**June 2020 Design Review Panel Feedback**

# 04 / Design Proposals

## 4.02 PROPOSED MASSING AND DESIGN

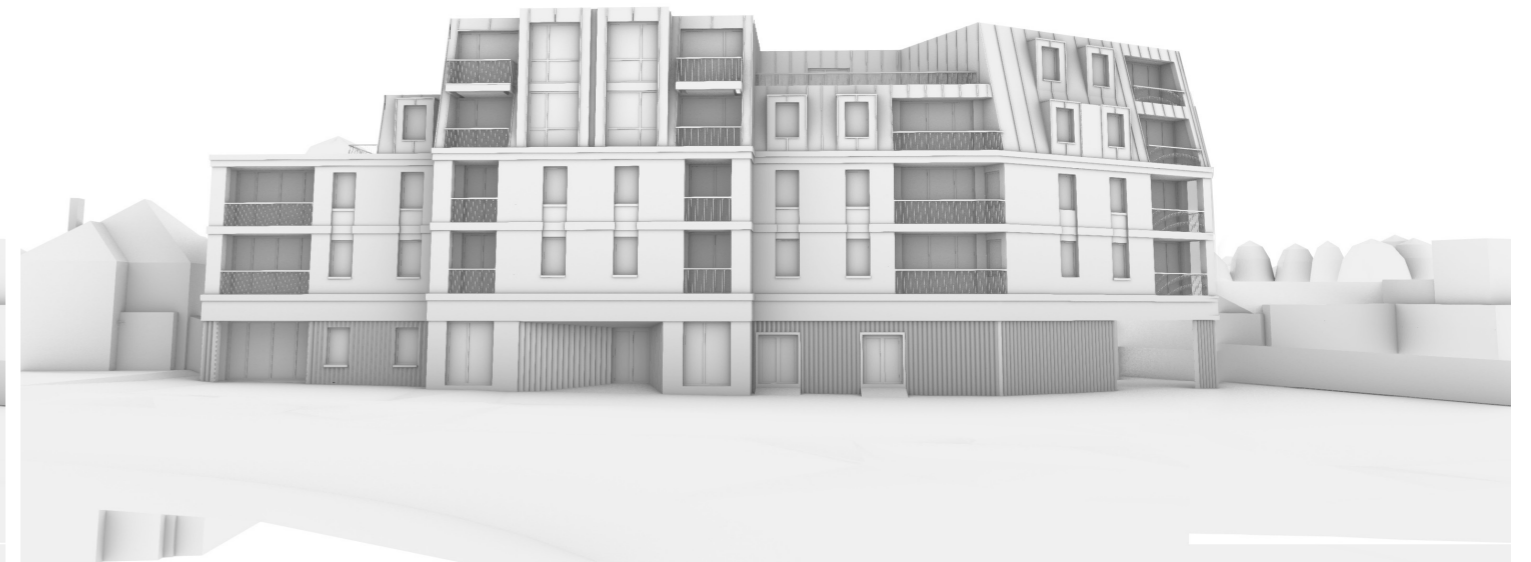
As part of consultation with Brent officers, we presented design 01 below with the feedback being that the northern part of the frontage was too dominant and should be subservient to the main central elevation facing the roundabout. In response, the below shows how we worked through several options. Following the DRP and third pre-app feedback a further step has been taken and the massing towards the Formula One site has been substantially reduced, as shown in the design concept section of this document.
